**TOWNSHIP OF SOUTH WHITEHALL
LEHIGH COUNTY, PENNSYLVANIA**

PROPOSED COMMERCIAL DEVELOPMENT 1810 PA ROUTE 309
MAJOR PLAN 2020-103
ATTACHMENTS

TO: PLANNING COMMISSION
FROM: GREGG ADAMS, PLANNER
SUBJECT: PROPOSED COMMERCIAL DEVELOPMENT 1810 PA RTE 309
MAJOR PLAN 2020-103
REQUEST FOR SKETCH PLAN REVIEW

RE: 1810 PA Route 309 Wawa
South Whitehall Township, Lehigh County, Pennsylvania
Sketch Plan Review
SWT File Application No. 2020-103

SHEET NUMBER:
C-301

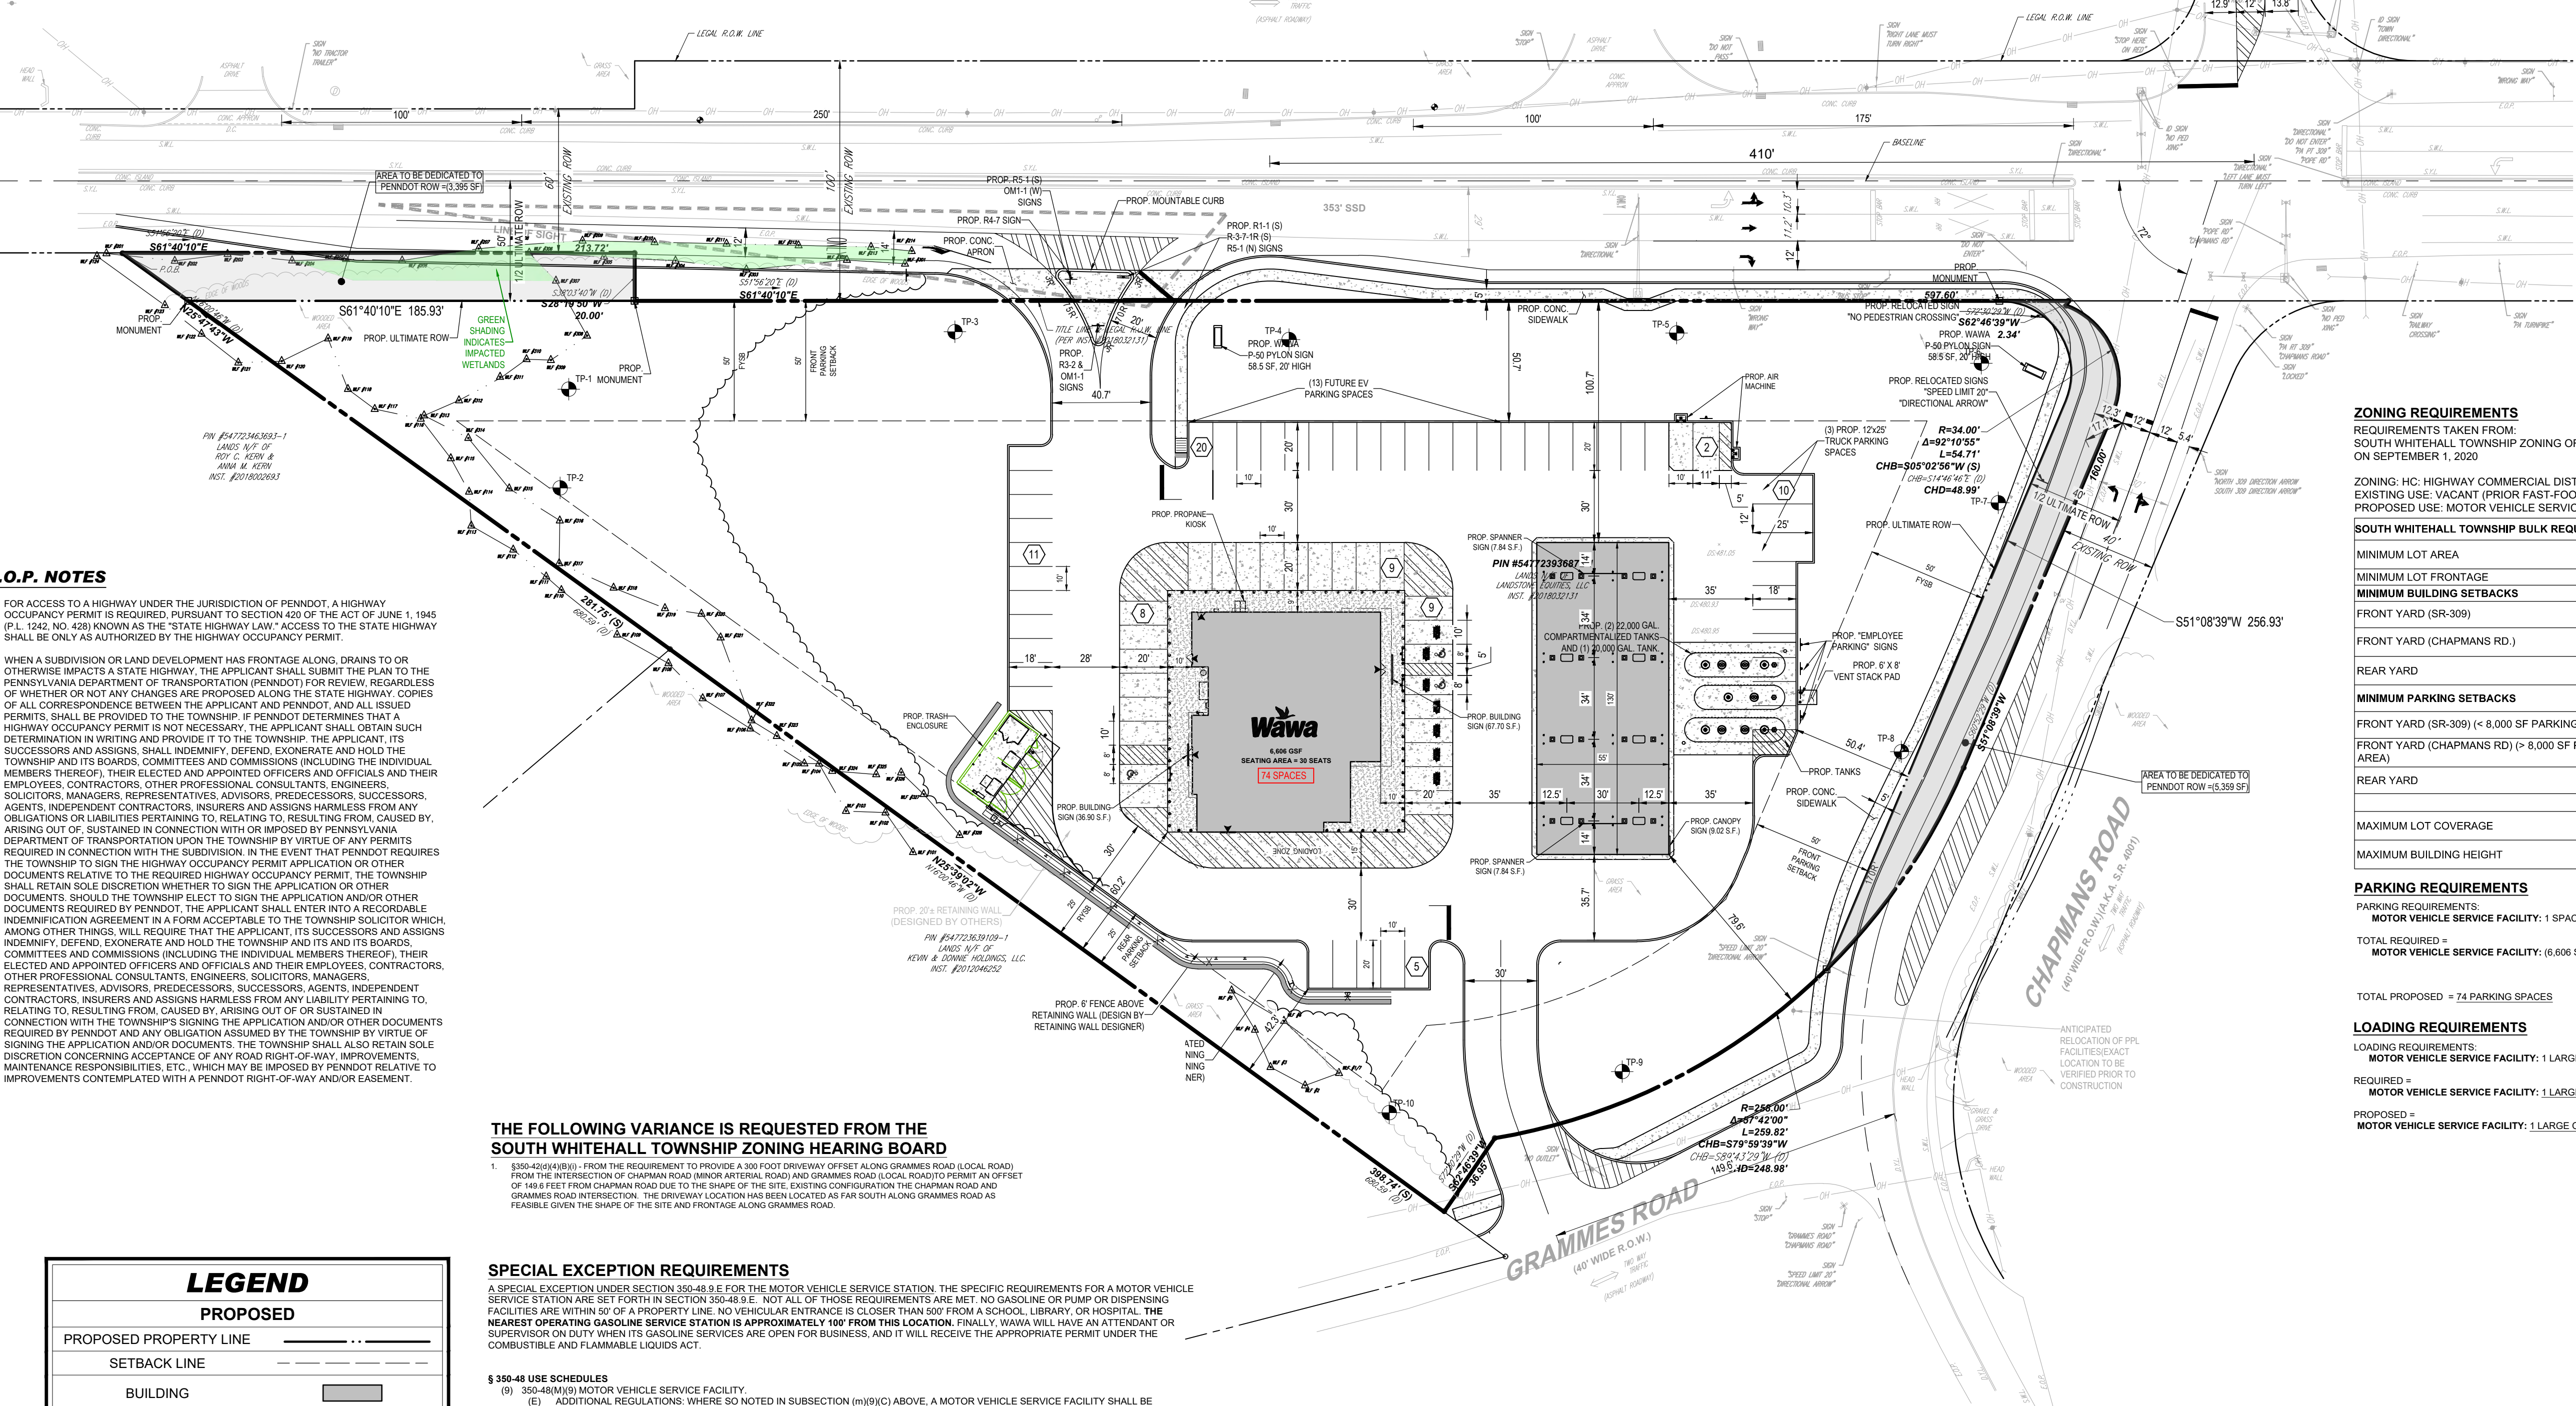
- 1. **Zoning § 350-42(b)(4)(B)** – Screening shall be provided for the proposed trash enclosure and loading zone from view from public streets.
- 2. * **Zoning § 350-42(d)(4)(B)(i); SALDO § 312-36(C)(4)(b)[1];** – The proposed driveway centerline intersection with Grammes Road shall be at least 300 feet from the intersection of Chapmans Road, a Minor Arterial roadway. The proposed driveway has a separation of 149.6’ from the Chapmans Road centerline.

- 3. **Zoning § 350-42(t)(2); SALDO § 312-35.B.(3)(d)[1]** – The ultimate right-of-way for Grammes Road, a local roadway, shall be 60’ in width. Additional right-of-way may need to be provided.

- 4. **Zoning § 350-48(m)(9)(E)(ix)[3][e]** – No sign with an electronic graphic display shall be located within a two-hundred-fifty-foot radius of intersecting centerlines of public streets at an intersection controlled by a traffic signal or similar safety device. The proposed sign at the southwest corner of PA Route 309 and Chapmans Road is located approximately 120’ from the centerline intersection. The applicant shall clarify if an electronic graphic display is proposed.

- 5. **Zoning § 350-48(m)(9)(E)(ix)[3][f]** – No sign with an electronic graphic display shall be located within a one-hundred-foot radius from the intersecting centerlines of a public street and a nonresidential driveway. The proposed sign at the eastern side of the proposed driveway at PA Route 309 is located approximately 80’ from the centerline intersection. The applicant shall clarify if an electronic graphic display is proposed.

- 6. **Zoning § 350-48(o)(2)(E)(ii)[3]**– When the computation of the number of required parking spaces results in a fraction, such fractions shall be resolved to the next highest whole number. The total required number of parking spaces shall be 75 to account for the fraction generated from the gross floor area calculation.

- 7. **Zoning § 350-48(o)(2)(E)(iii)[2][a][i]**– All nonparallel standard parking spaces shall be 18.5 feet long. It is noted that several standard spaces are 18’ long.

10. **SALDO § 312-10.B.(8)** – Topographic contours from available data shall be shown on the Concept Plan.
11. **SALDO § 312-10.B.(10)** – Property boundaries within 200 feet of the site shall be shown on the Concept Plan.

12. **SALDO § 312-10.B.(12)** – The extent of the wetlands and woodlands shall be clearly labeled on the plan.
13. **SALDO § 312-10.B.(13)** – The project narrative references two managed release concept detention basins. These locations shall be shown on the plan.

14. **SALDO § 312-35.A.(5)** – The following traffic related comments shall be addressed:
 - A. Sight distance calculations should be provided for the full-access driveway on Grammes Road that demonstrate, at a minimum, that Stopping Sight Distance (SSD) requirements are met using the posted speed limit of Grammes Road. The sight distance calculations should demonstrate that the required SSD can be accommodated on Grammes Road (not extending onto Chapmans Road) since a motorist turning left out of the proposed full-access driveway will not be able to discern whether a vehicle traveling south on Chapmans Road will turn right onto Grammes Road or continue on Chapmans Road.

- B. Level of Service and Queue analyses and summary tables should be provided for the intersection of Chapmans Road and Grammes Road to determine the extent of queueing on Grammes Road eastbound and any resulting negative impacts to the proposed full-access driveway (i.e. blocking of the full-access driveway).

16. **SALDO § 312-35.B.(3)(a)[1][c]** – Curbs at all intersections shall be rounded by a minimum radius of 30 feet. Turning templates should be provided for a WB-67 design vehicle to demonstrate that tractor-trailers to/from Grammes Road can turn from Chapmans Road onto Grammes Road without encroaching into

oncoming lanes of traffic on either Chapmans Road or Grammes Road. A larger radius may be required.

17. * **SALDO § 312-35.B.(3)(a)[2][a][i]** – To provide adequate and proper pedestrian circulation, sidewalks shall be required within all subdivisions. The Planning Commission may wish to comment on whether sidewalk should be extended along the full frontage of PA Route 309.

18. **SALDO § 312-35.B.(3)(a)[4]** – Concrete driveway aprons shall be installed for all driveways which will cross an existing or proposed sidewalk.
19. **SALDO § 312-35.B.(3)(d)[1]** – The proposed Grammes Road curblineline shall be aligned to reflect an ultimate 36' wide local road cartway. In addition, the constructed improvements provided on the adjacent Push & Pull Autobody shall be shown on the plan. Proposed improvements shall adequately tie-in to constructed improvements.

20. **SALDO § 312-36.C.(1)** – A Highway Occupancy Permit (HOP) will be required from the Pennsylvania Department of Transportation.
21. **SALDO § 312-36.C.(5)(a)** – Driveways for nonresidential subdivisions shall not exceed 40 feet in width at the right-of-way line.

32. **Section § 296-14.D.** – Wetlands are proposed to be impacted by the proposed turn lane for the driveway on PA Route 309. The applicant shall consult with DEP on the limitations and Chapter 105 permit requirements for indirect and direct disturbances to wetlands. In addition, a copy of the Wetland Delineation report should be submitted to the Township.

33. **Section § 296-15.P.** – Stormwater runoff from hot spot land uses, such as the vehicle fueling station, shall be pretreated.
34. **Section § 296-16** – The site proposes more than 10,000 square feet of impervious cover and therefore a drainage plan is required in accordance with the Stormwater Management ordinance. The site appears to lie with Subarea 118 of the Jordan Creek Watershed Act 167 Plan. This subarea is designated as a 30/100 release rate district. The two-year post-development peak discharge rate must be controlled to 30% of the predevelopment two-year runoff peak. Further, the ten-, twenty-five, and 100-year post-development peak runoff rate must be controlled to the stated percentage of the predevelopment peak.

36. The applicant should consider relocating the four (4) parking spaces in the northwest corner of the site nearest the incoming traffic lane at the proposed driveway entrance from PA Route 309. We ultimately defer to PennDOT's acceptance of the location of these spaces.

1. All comments in the Township Engineer's review letter dated August 10, 2023, shall be addressed.
2. Section 350-42(b)(4)(B) Buffer Strips. The proposed landscaping around all the dumpster enclosures shall be on all sides not intended for dumpster access. This includes transformers, generators, or other like equipment which are greater than four (4) feet in any one dimension. Screening shall be required for any proposed trash dumpsters.
3. Section 350-42(d)(4)(B)(i) Driveways. PA Route 309 and Chapmans Road are Arterial Roads. The driveway separation distance from the centerline of Chapmans Road to the centerline of the driveway is 300 feet. The plan proposes a separation distance of 149.6 feet from Chapmans Rd. A variance is required.

4. Section 350-42(e)(3)(B) Fences and Retaining Walls. A previous plan indicated a height of 24.5 feet for the proposed retaining wall. The Retaining walls may not be taller than six feet above the uphill (retained side) of the adjacent ground. Show and label on the plan the height of wall from grade from the parking lot side and the neighboring property side. Clarify the placement of the fence with regard to the wall.

5. Section 350-42(t)(2) Ultimate Right-of-Way Widths for Roads. Grammes Road is a local road and requires a 60 feet Ultimate Right-of-Way. Show and label on the plan the proposed right of way line and the distance from the centerline.

6. Section 350-48(e)(1) Electric Vehicle Charging Station. There are 13 spaces in the upper parking area that are noted for future EV parking spaces. A note shall be placed on the plan that *“the parking spaces from which the charging station may be accessed shall not be restricted to vehicle charging-only parking”*. If the parking spaces from which the charging station may be accessed are restricted in opposition to the preceding sentence, those spaces shall not be counted within the total off-street parking spaces required by the provisions of Section 350-48(o)(2) by the associated primary use.

8. Section 350-48(m)(9)(D) Minimum Off-Street Parking Calculation for Motor Vehicle Service Facilities. Where 75 spaces are required, the plan proposes 74 (Section 350-48(o)(2)(E)((ii)(3) where computation results in a fraction, they are resolved to the next highest whole number. Parking spaces are allowable to be shown under the canopy next to the individual gas pumps. Show and label the required spaces. NOTE: Since parking spaces can be utilized at the pumps, the parking spaces to the Northwest of the entrance from Route 309 should be reevaluated for safe entry and exit of the first couple parking spaces.

10. Section 350-48(o)(2)(E)(iii)(2)(a)(i) Parking Space Size. All nonparallel standard parking spaces shall be 9 feet wide and 18.5 feet long.
11. Section 350-48(o)(2)(E)(v)(b) Shade Trees. Provide one shade tree for every ten (10) parking spaces located in a planned manner within or adjacent to the parking lot areas. Indicate whether the trees are the parking lot trees required in section (b), section (c), or if they are the required street tree planting to be located within the right-of-way.
